STAFFORDSHIRE
POLICE

Date: 6 December 2023

Application: SMD/2023/0546
Location: St. Edward's Church of England Middle School, Westwood Road, Leek
Proposal: New 2.4m high fencing to school boundary, new 1.2m high bow top railing to internal macadam paths, and new steps with handrail

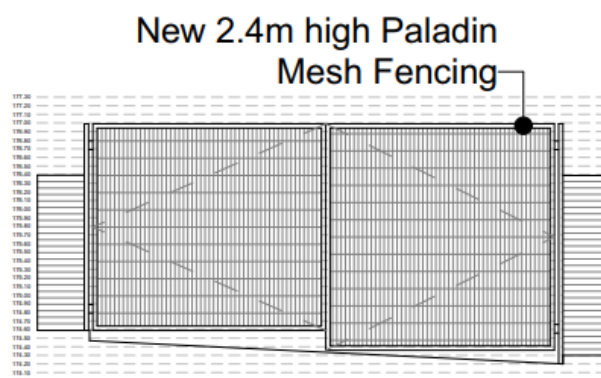
The proposed Westwood Road E1 vehicle gates drawing (see opposite) shows a gap under both gates, the left-hand one being more pronounced. Whether this would allow anyone to crawl under the gates is unclear, but this needs to be assessed and an appropriate counter measure incorporated, should it prove to be a possible issue.

Furthermore, the existing brick piers are to be retained. These will be noticeably lower than the new automated double gates that are to be installed and could provide the means to overcome the gates. If they are to be retained, it would seem opportune to eliminate any possible vulnerability that might attach to them, as part of these proposals. Denying access to them externally by boxing them with a small section of the same 2.4m high welded mesh fence matching the gates would be one obvious option that might accomplish this.

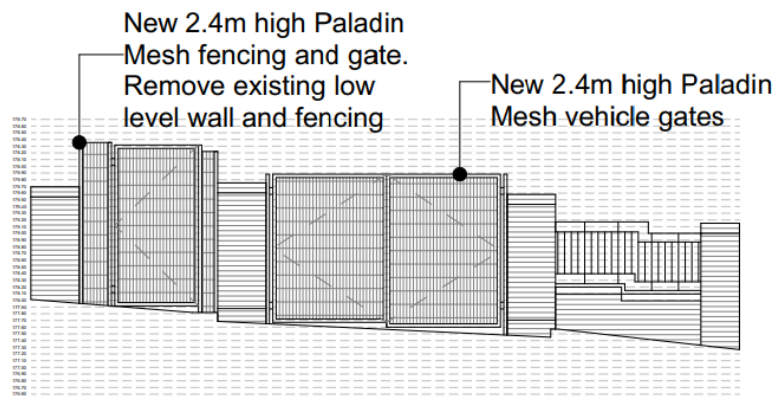
It is considered that there is also scope and need to improve security arrangements at E2 access point on Westwood Road, shown opposite.

Seemingly, potential climbing aids would remain. Certainly, the area to the right with lower piers, low wall and flat-topped railings appears vulnerable. The retained lower pier on the left has a litter bin (not shown) directly in front of it, which in

combination provides perfect stepping/climbing aids. It would seem prudent to revise the proposals for this school entrance. Options could include removal of the left pier at the same time as the proposed removal of the low-level wall/fencing and extend the 2.4m fencing further to the left. Relocating the bin slightly to the left could remove its use as a potential climbing aid. Removing the retained low-level wall and fence, and brick pier on the right, and replacing them with the 2.4m high fencing should be considered.

One might have thought that the changes being considered would provide the perfect opportunity to remove all of the brick piers at E2 including the two unmatched piers either side of double gates. This would certainly be an option to provide some consistency and clean lines, aside from any vulnerability attached to retaining large flat-topped, lower piers. The 2.4m high welded mesh fencing/gating could then be used for the whole width of this area. It would be argued that any 'heritage' value of retaining the brick piers would be negligible. If the two main piers need to be retained, there should be consideration to protect/deny external access to them by extending the 2.4m high welded mesh around them. There would undoubtedly appear to be scope to reconsider what is proposed here to maximise security opportunity and eliminate any residual weaknesses.
